Amendments To The Drawings:

REMARKS

16 SERIAL NO: 10/075.938 For: Error Control Coding Method and System For Non-Volatile Memory Attorney Docket No.: 67,200-489

FIG. 1

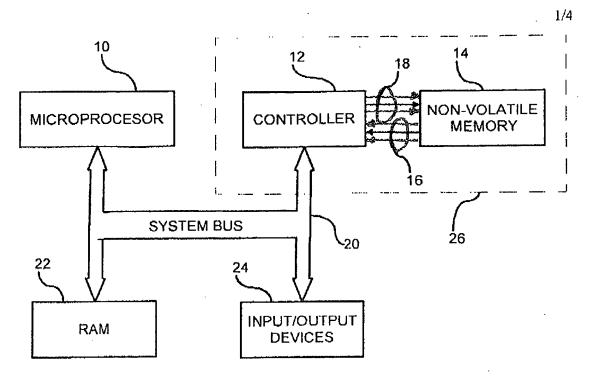
FIG.'s 1-4 are amended to show "data bus" and "I/O terminal" elements as described in the specification. An annotated sheet for FIG.'s 1-4 are attached. Replacement sheets for the drawings are being submitted pursuant to 37 CFR 1.121(d).
